ORDINARY MEETING 14 APRIL 2015	5.1
---	------------

RECONFIGURING A LOT (CODE ASSESSMENT) (1 LOT INTO 17 LOTS) –
 2L OASIS DRIVE, WONGA BEACH

Jenny Elphinstone: ROL 591/2014: 436363

<u>PROPOSAL:</u>	RECONFIGURING A LOT (1 LOT INTO 17 LOTS)
<u>APPLICANT:</u>	WROXALL INVESTMENTS PTY LTD C/- FLANAGAN CONSULTING GROUP PO BOX 5820 CAIRNS QLD 4870
<u>LOCATION OF SITE:</u>	2L OASIS DRIVE, WONGA BEACH
<u>PROPERTY:</u>	LOT 2 ON SP259953
<u>LOCALITY:</u>	COASTAL SUBURBS
<u>PLANNING AREA:</u>	TOURIST AND RESIDENTIAL
<u>PLANNING SCHEME:</u>	DOUGLAS SHIRE PLANNING SCHEME 2008
<u>REFERRAL AGENCIES:</u>	NOT APPLICABLE
<u>NUMBER OF SUBMITTERS:</u>	NOT APPLICABLE
<u>STATUTORY ASSESSMENT DEADLINE:</u>	EXPIRED
<u>APPLICATION DATE:</u>	10 DECEMBER 2014
<u>APPENDIX:</u>	<ol style="list-style-type: none"> 1. PROPOSAL PLAN(S) & DOCUMENT(S) TO BE AMENDED BY THE CONDITIONS OF THE APPROVAL 2. INFRASTRUCTURE CHARGES NOTICE 3: SUPPORTING INFORMATION TO PLANNING REPORT

LOT 2 SP259953
 Proposed 17 Subdivision, Wonga Beach
PROPOSAL PLAN

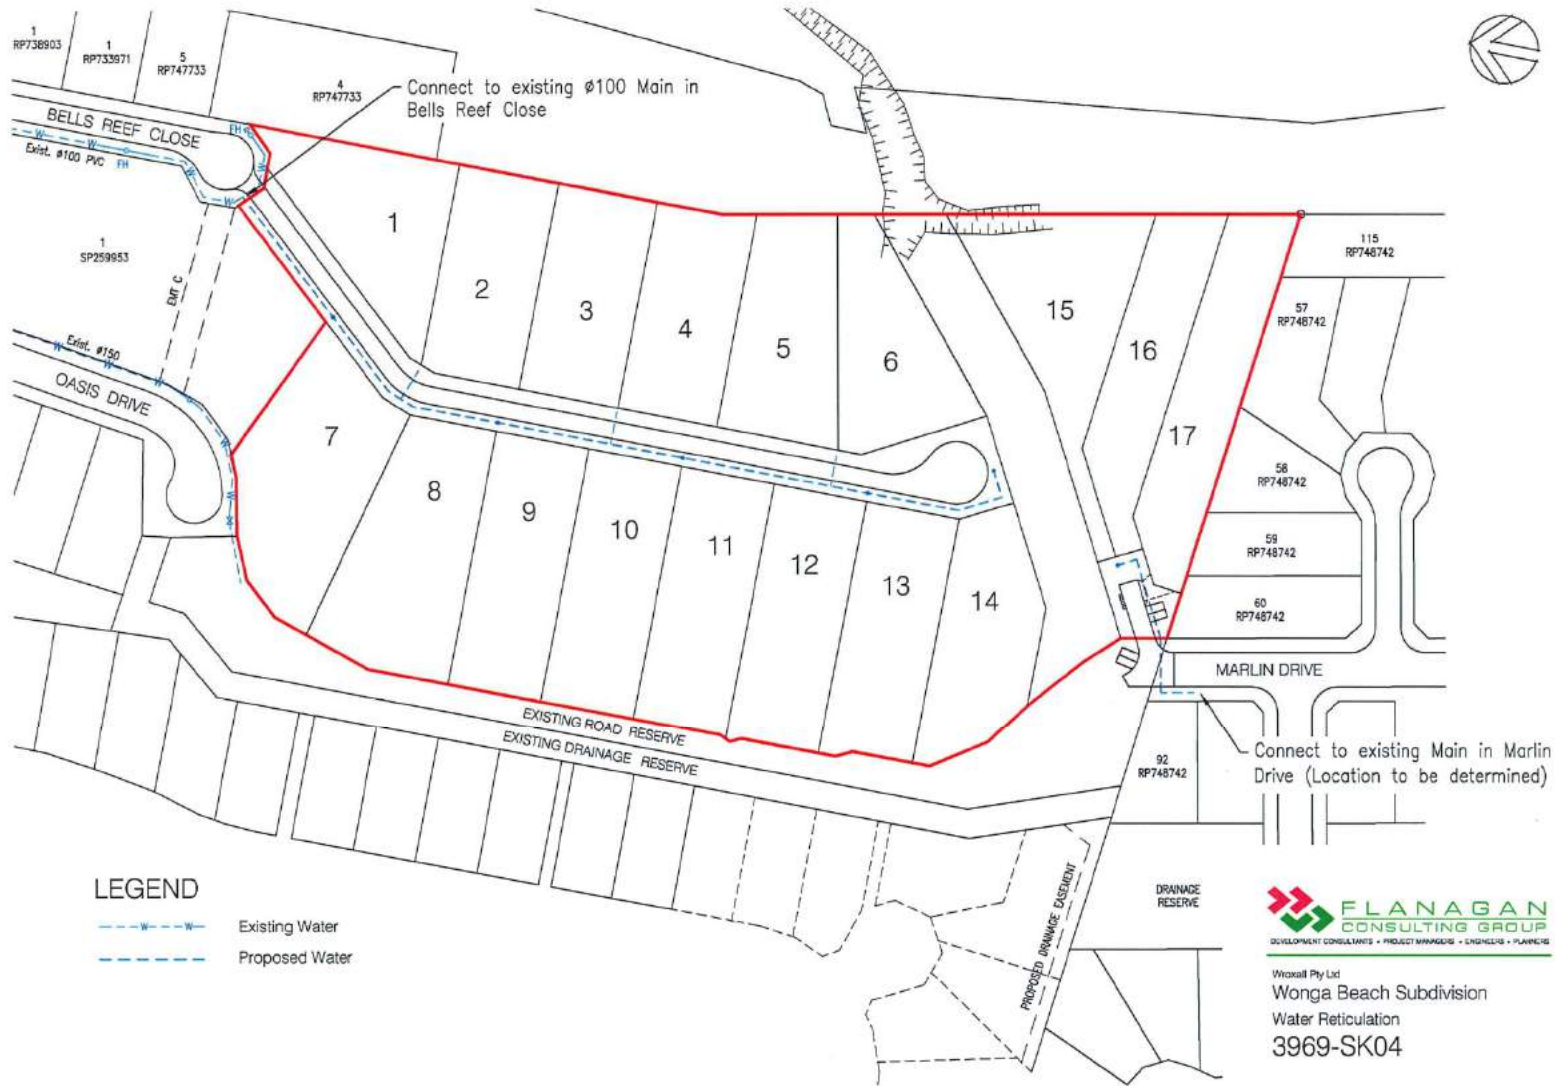
4. The street layout and design is to be generally in accordance with Flanagan Consulting Group (FCG) Proposal Plan, Sketch 3969-SK03 subject to:
 - a. Deletion of the catch drain and easement at the eastern boundary of Lots 1-6 and Lots 15-17 inclusive;

- b. Setback of fill areas a minimum of 6m from the property boundary from all roads and Esplanade.**
- c. Setback of fill areas a minimum of 3.0 metres from the southern boundary of proposed Lot 17.**

- d. The fill pad for proposed Lot 7 is to be extended to the northern boundary and retained;**
- e. The fill pad for Lots 1 to 6 inclusive must be a continual plane with the pads draining to the new road to the west.**

- f. The fill pad for Lots 7 to 14 inclusive must be a continual plane with the pads draining to the new road to the east. The rear of these lots is to be graded to the west to negate ponding of water between the fill pad and the existing road reserve;**

- g. The fill pad for Lots 15 to 17 inclusive to be a continual plane with the pads draining to the new drainage reserve**
- h. On-street car parking spaces in the vicinity of lots 15 to 17 are to be provided as shown on FCG Sketches 3969-SK03 to 06 and the maintenance access to the new drainage reserve are to be designed with minimal increase of stormwater drainage to Marlin Drive.**

- l. A 6m setback area from the eastern boundary (to the Esplanade) is to be included in a conservation covenant area and is to be vegetated in accordance with condition 25;**

FLANAGAN CONSULTING GROUP
 DEVELOPMENT CONSULTANTS • PROJECT MANAGERS • ENGINEERS • PLANNERS
 Wroakill Pty Ltd
 Wonga Beach Subdivision
 Stormwater Drainage
 3969-SK05

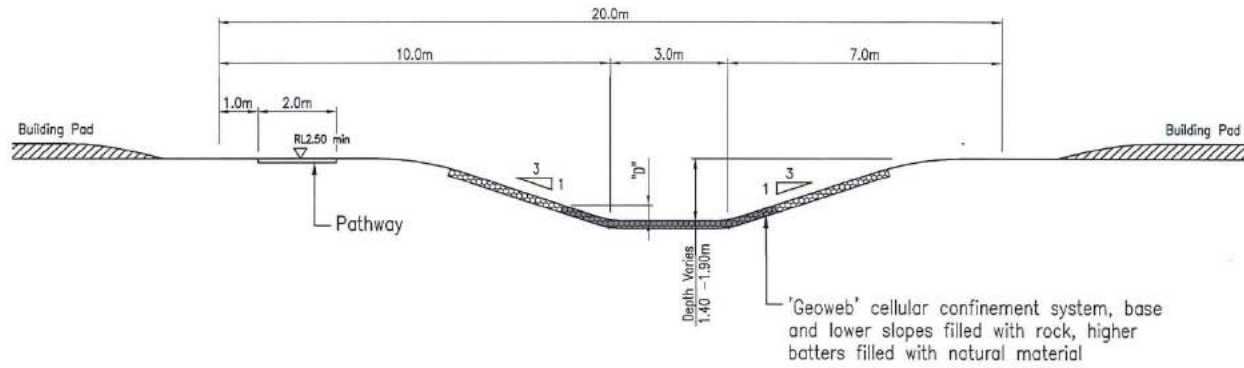
- a. The earthworks fill zones are to be continuous across the boundaries of lots to avoid localised low points between properties;
 - b. The rear of allotments are to be graded evenly in accordance with the concepts shown on FCG Sketch 3969-SK05 to ensure that they remain free draining throughout the property and through to the drainage reserve or Esplanade area.

19. The subject land must be drained to the satisfaction of the Chief Executive Officer generally in accordance with FCG sketch 3969-SK05 . In particular:

frontages, drainage easements or drainage reserves and discharged to the existing drainage system via storm water quality device(s). Note the drainage easement shown on FCG Sketch 3969-SK05 in the eastern side of Lots 2 to 6, 15 and 16 is not required.

PROPOSED DRAINAGE CHANNEL
1:100

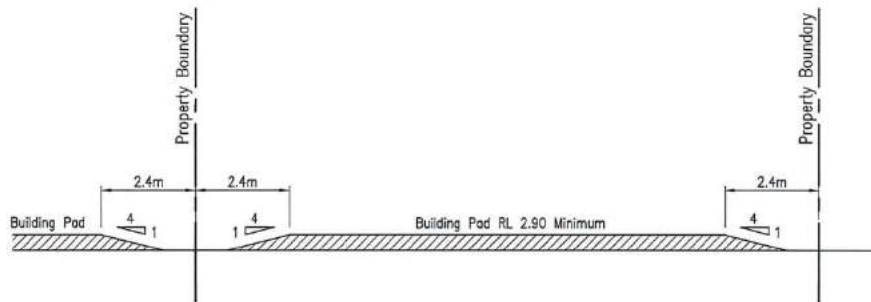
- n. Provide a suitable lining and finish to the 20m wide drainage easement area to provide a stabilised channel that is able to be traversed by Council's maintenance equipment; and**

17. The applicant / owner must undertake the development of the land in accordance with the findings of the Drainage Study dated 28 November 2013 prepared by DHI Water and Environment Pty Ltd as detailed by FCG Sketch 3969-SK05 and SK06 with a robust channel base lining to facilitate trafficability and maintenance to the satisfaction of the Chief Executive Officer.

Wroozell Pty Ltd
Wonga Beach Subdivision
Drainage Details / Earthworks Pad
3969-SK06

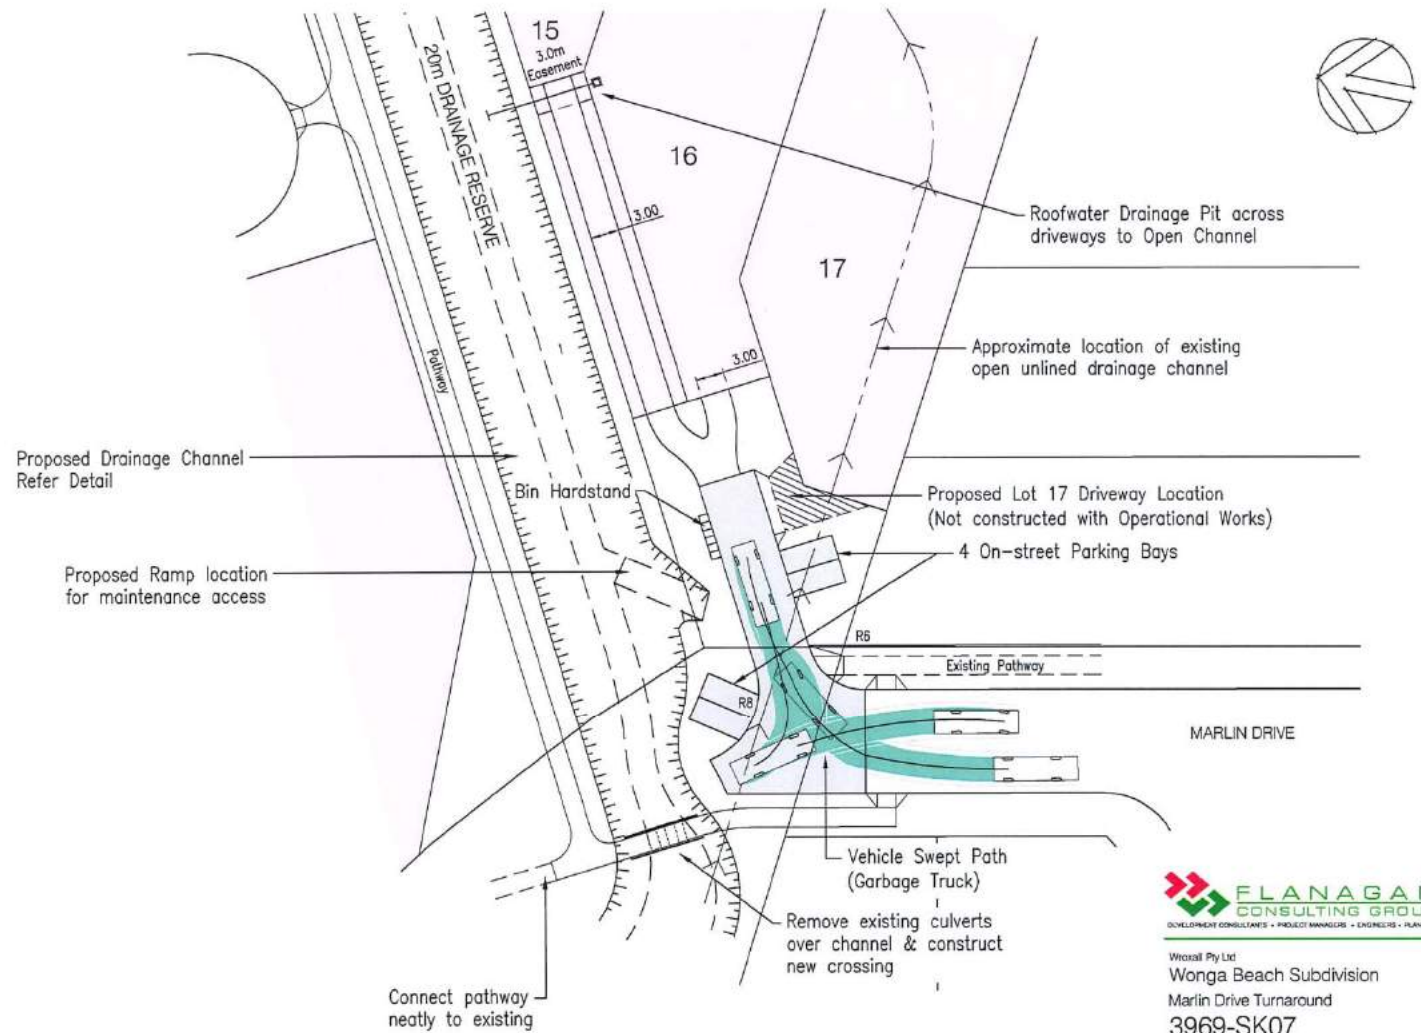
10. The concept for excavation and earthworks as detailed on FCG Sketch 3969-SK05 and SK06 is generally approved subject to compliance with the on-site disposal and drainage conditions and subject to the following amendments:

- c. The nominated fill level of 2.9m is to be increased to 4.04m AHD level unless otherwise approved by Council. Any reduction below 4.04m AHD must be supported by a further study, to the satisfaction of Council, to a lower level than 4.04 but no lower than 3.54m AHD. Any reduction below 4.04m AHD must utilise at least a 0.3 Sea Level Rise (SLR) and increase in intensity of cyclone action.
